Memorandum

Re: Traffic Signals, Intersection of First Street and First Avenue (IA Hwy 1)

AGREEMENT FOR APPROVAL OF A TRAFFIC CONTROL DEVICE

Traffic Signal Plan

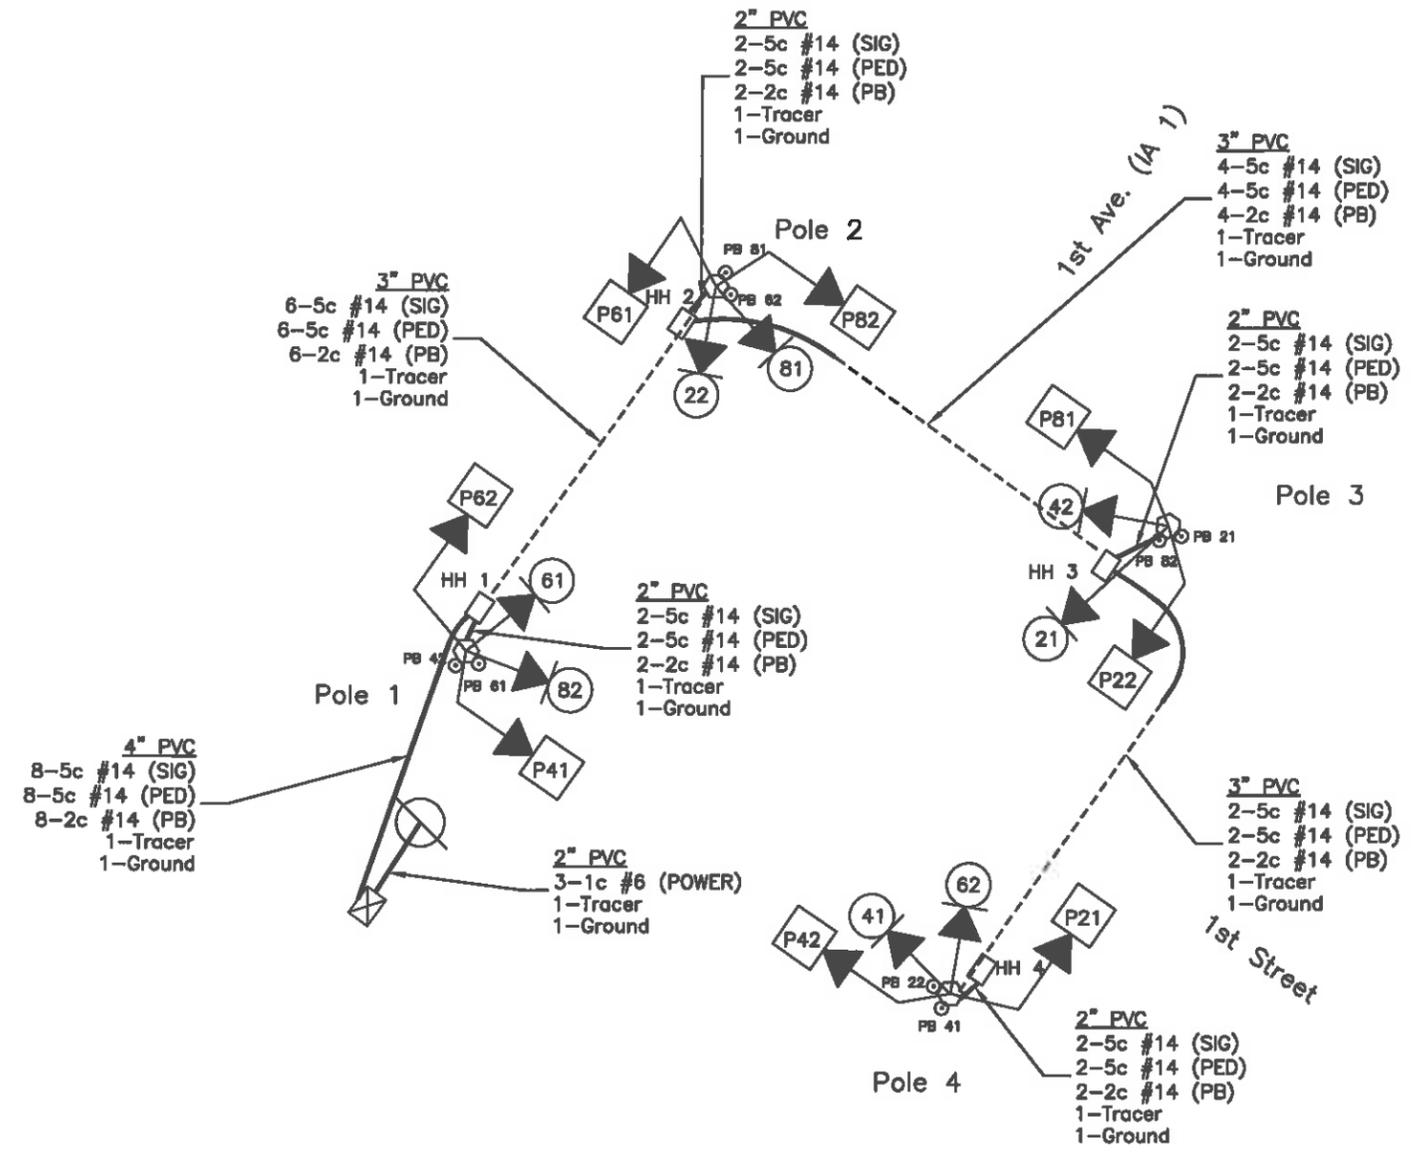
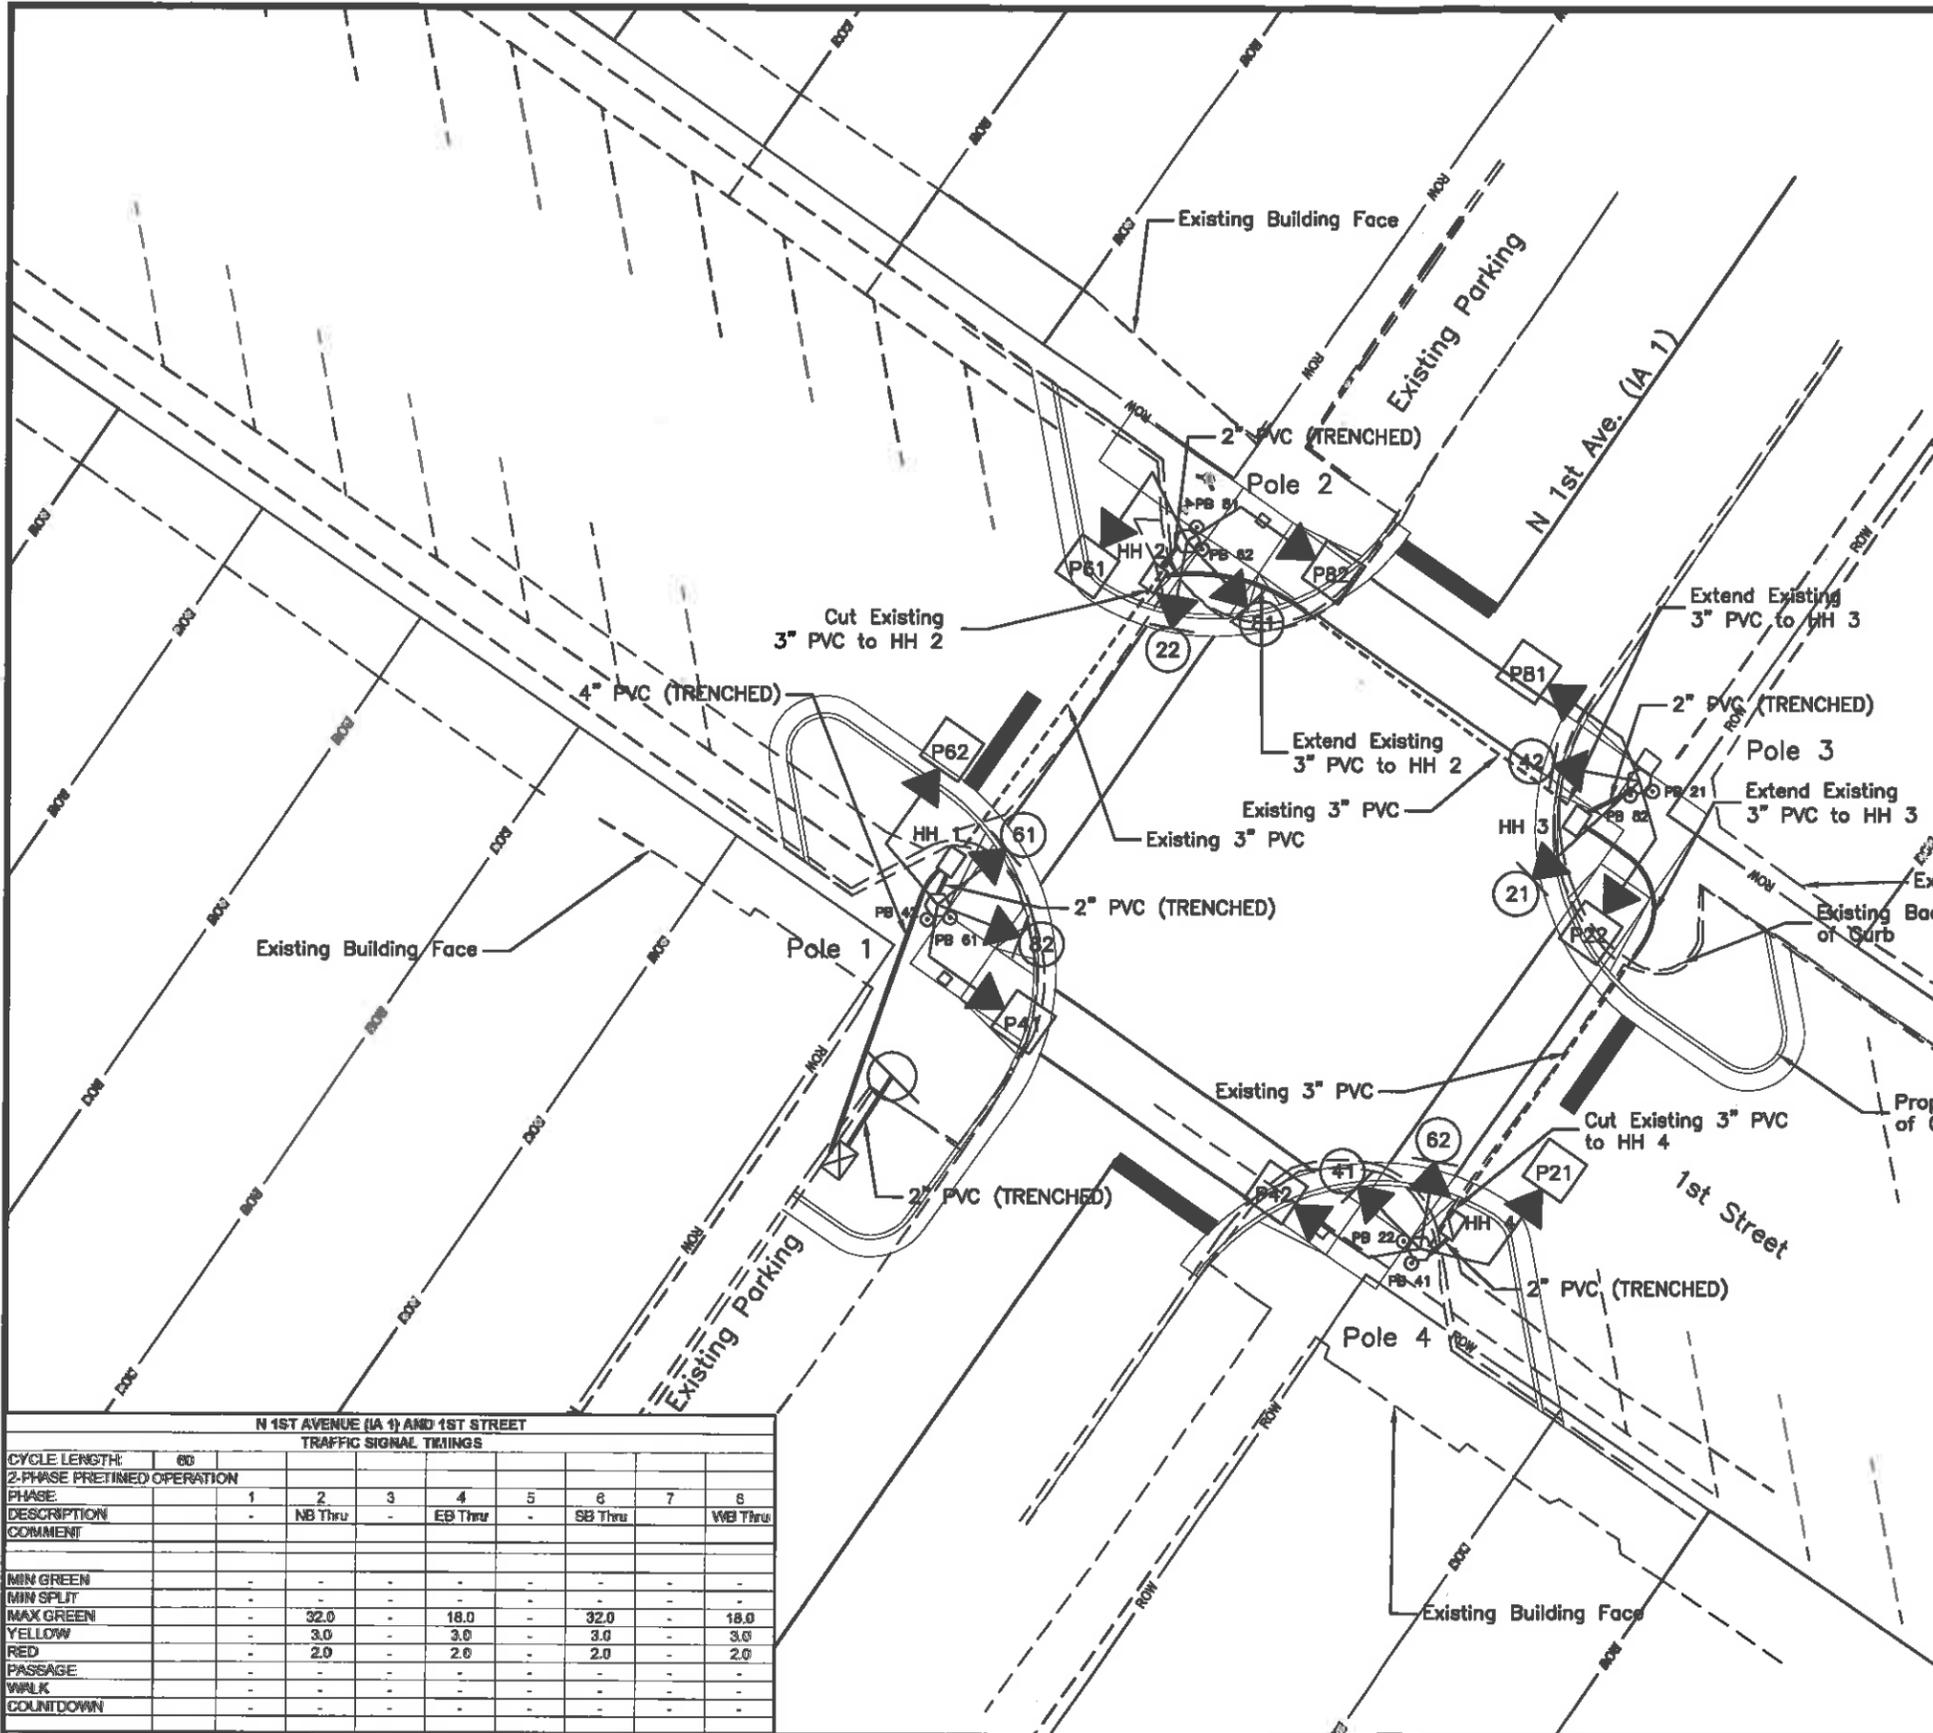
The pole locations would remain the same as what I provided to IDOT. In that original plan we had 4 traffic signal pedestal posts with two signal heads on each post. If we go to mast arms, there would still be four signal posts, but they would have mast arms that extend out over the street and there would be one signal head on each post and the other signal head would move to the mast arm.

I could look at the crash data they are citing and see if there is a statistically significant crash rate. From a safety perspective, visibility is generally better with mast arm signals. However, I don't know if the City feels that it would adversely affect the aesthetics of the downtown. As far as the crashes with obscured visibility, the City could trim some of the street trees on the intersection approaches to make sure the signals are more visible. The other thing we could offer IDOT is to install a warning beacon at the existing signal ahead signs that would flash yellow when the signal faces on Highway 1 are yellow or red. It takes some more wiring, but IDOT may allow that versus mast arm poles.

I asked our Office of Traffic and Safety (OT&S) to review these attachments and it seems that due to the crash history at this location, there are a few recommendations. The crash history shows 27 crashes in the last 10 years with 17 of them being "Ran Traffic Signal", "Fail to yield on left turn", or "Vision Obstructed". Because of this, OT&S recommends installing the signal heads on mast arms instead of pedestal poles.
